ADDENDUM NO. FOUR
JUSTICE CENTER MITIGATION PHASE 3 - IFB
PROJECT NO. 22-76
CITY OF THORNTON, CO

PURPOSE: To provide additional information and clarification to the solicitation documents for the above-referenced Project.

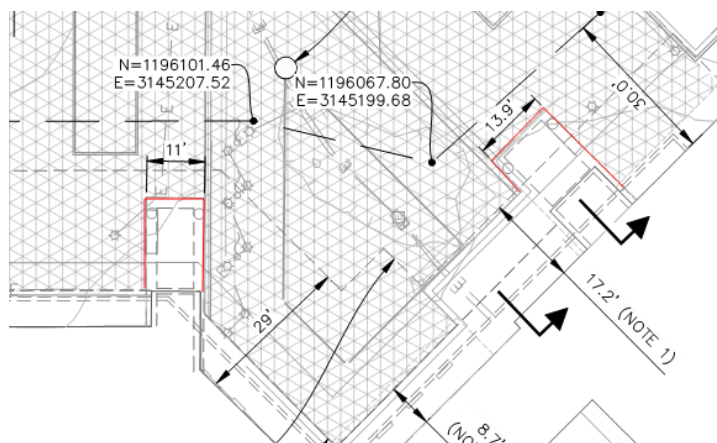
Question 9: Please advise where B/B-02 (as shown on D-04) occurs, specifically the excavation and removal of soil under grade beam.

Answer 9: This detail is applied where the geotextile is fixed to the grade beam around the door entrances to the Courts building and the Police building. See red line below. Actual limits may vary based on limits of MSEW-1 observed in the field.
